SCOPING OPINION:

Proposed Morgan Offshore Wind Project

Case Reference: EN010136

22 July 2022

Figure 1: The Morgan Array Scoping Boundary.

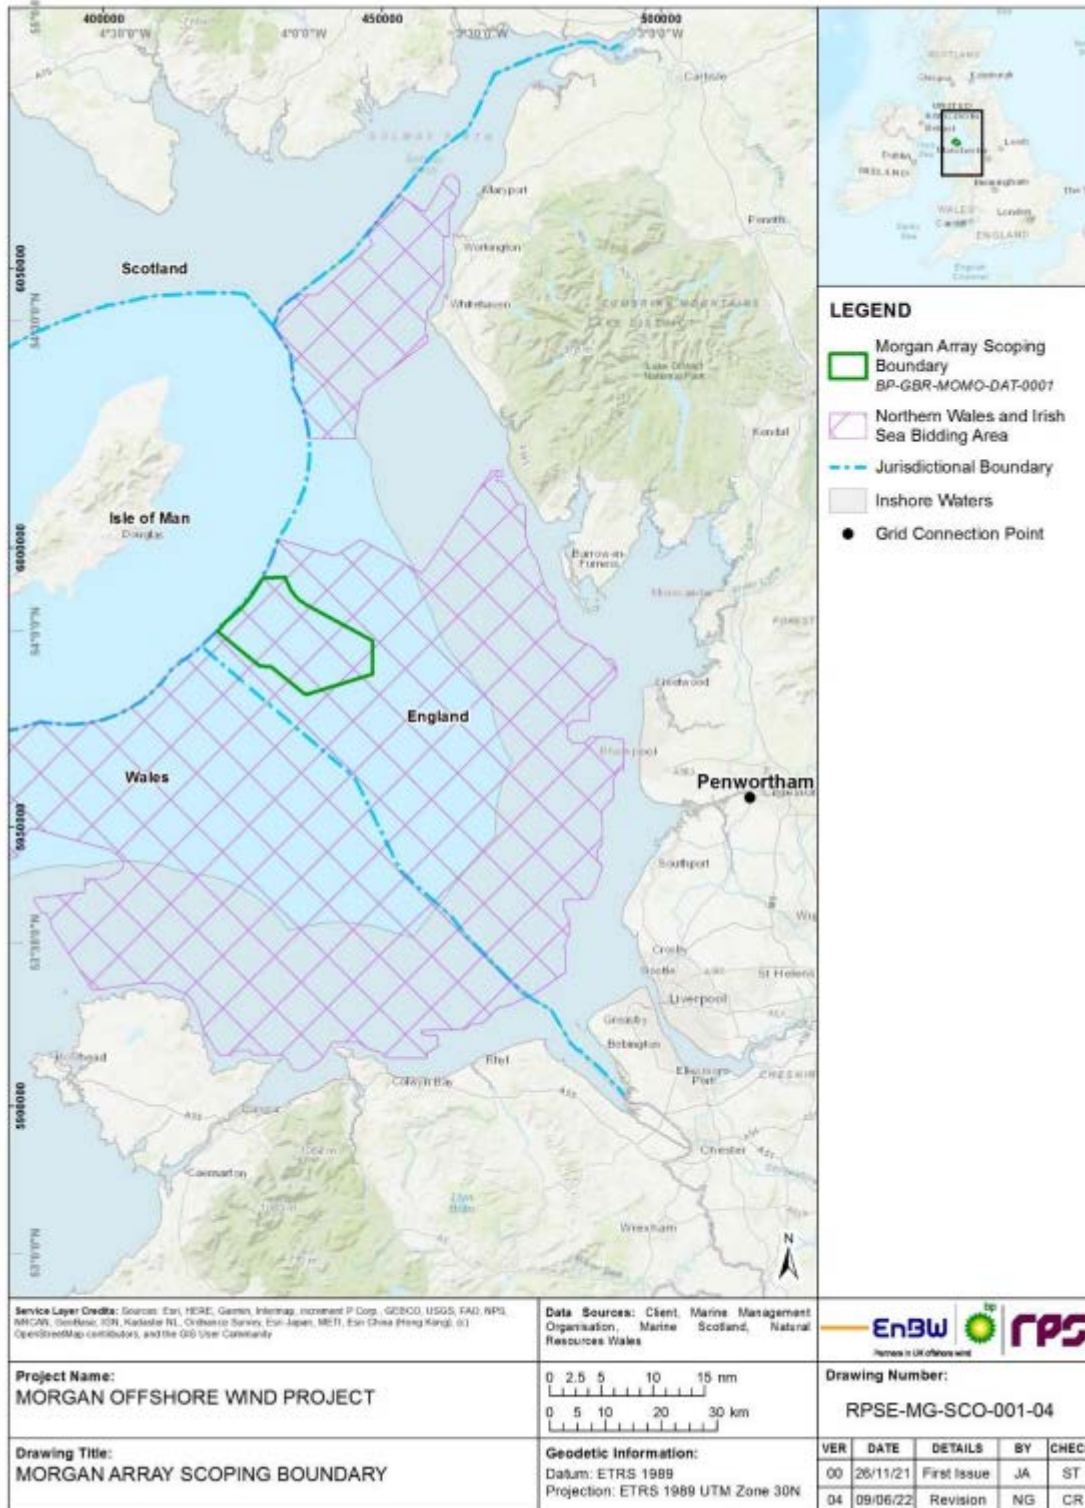
The Morgan Offshore Windfarm is located between 22.3km from the Isle of Man coastline and 36.2km from the northwest coast of England, the Scoping area is displayed in Figure 1 below.
